HORSHAM DISTRICT COUNCIL CONSULTATION

TO:	Horsham District Council – Planning Dept
LOCATION:	Land at Sumners Ponds Chapel Road Barns Green West Sussex
DESCRIPTION:	Application for Approval of Details Reserved by Conditions 18 and 19 to approved application DC/21/2697
REFERENCE:	DISC/25/0395
RECOMMENDATION:	Holding Objection / More Information / Modification

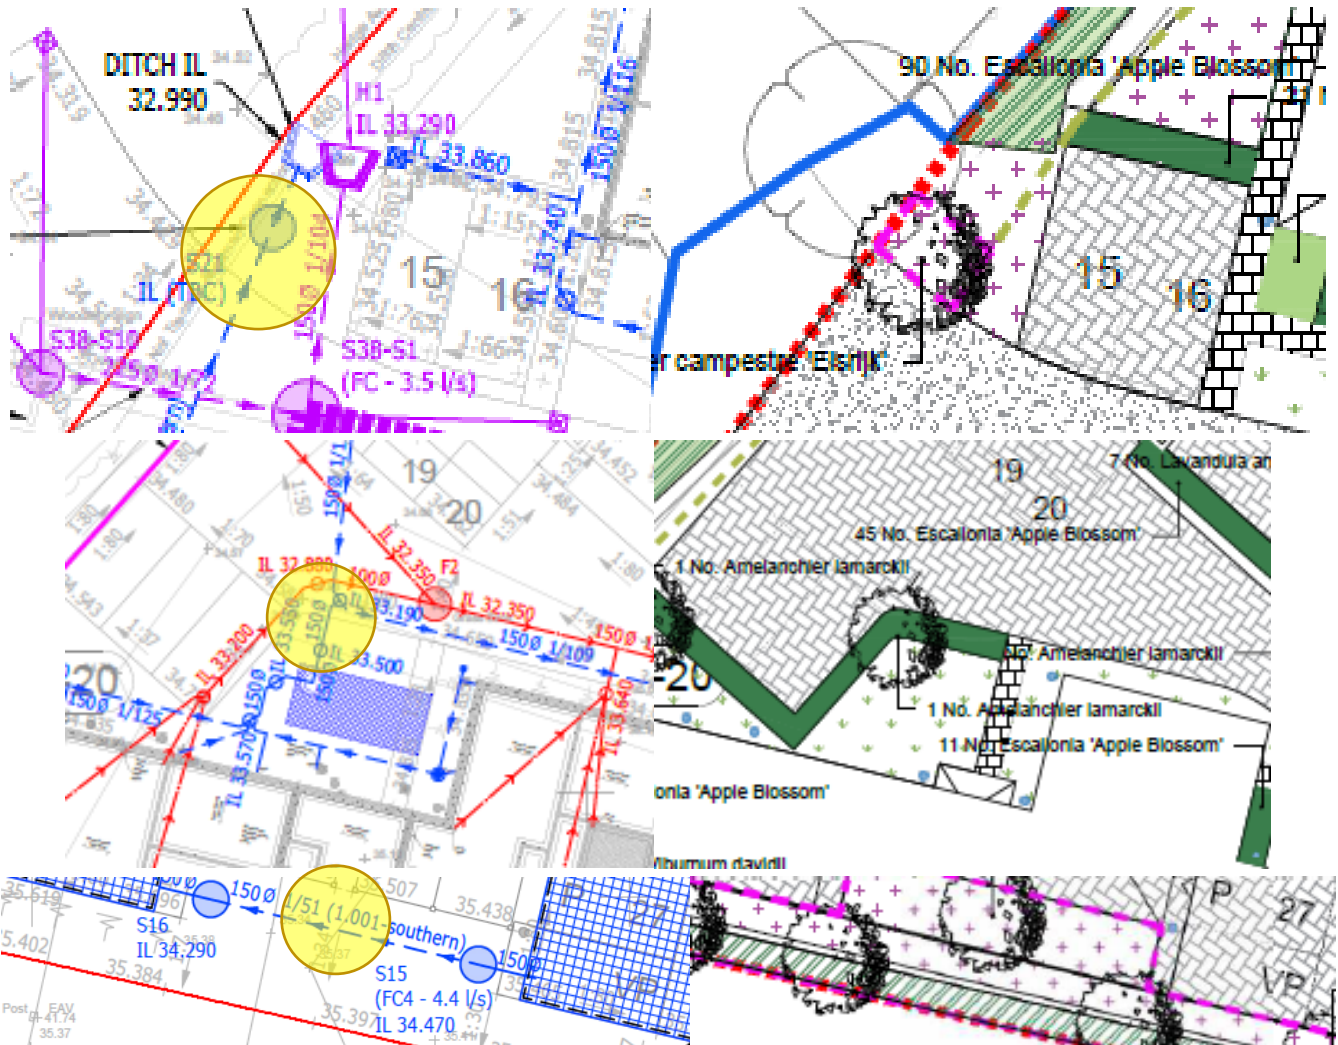
- a. The landscaping proposals have been coordinated with the attenuation tank locations, with thanks, however they remain uncoordinated with the drainage strategy. We note various conflicts with drainage runs, therefore we request the strategies are coordinated and that trees are re-located to ensure they can be delivered. Please see examples highlighted below.

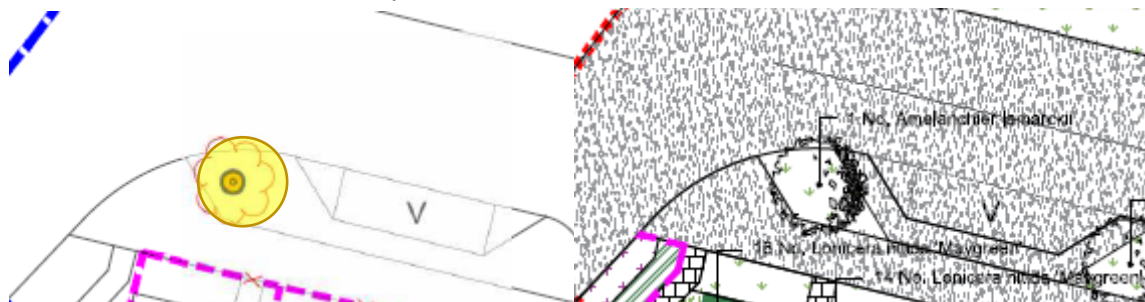
- b. As above, the landscape strategy must also be coordinated with the lighting strategy, ensuring that utility runs are indicated in addition to fixtures to ensure no further conflicts. Current areas of proximity and/or potential conflict are highlighted below and modification is thus requested.

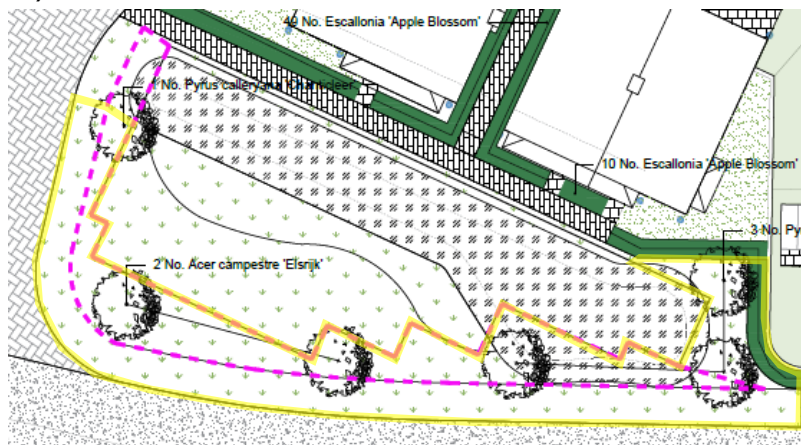
- c. Please reinstate tree adjacent to plot 7, highlighted in red below.

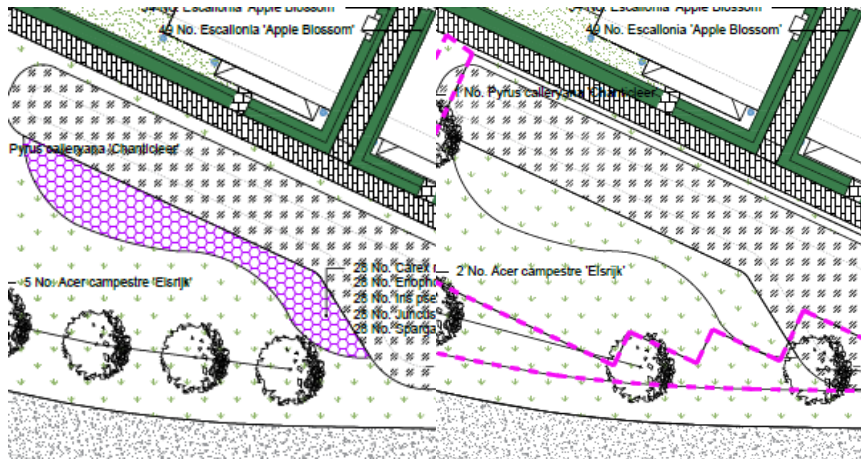
- d. Further to tree planting conflicts, concerns remain in regard to root barrier locations. While some locations have been included, with thanks, there remain various locations where they are required. In addition, drainage runs have not been factored in and thus we are not confident that all trees can be successfully delivered and established. Please review.
- e. As above, please amend the root barrier within the central green to avoid drainage runs and to align with the road to increase available rooting medium. See suggestion below in yellow.
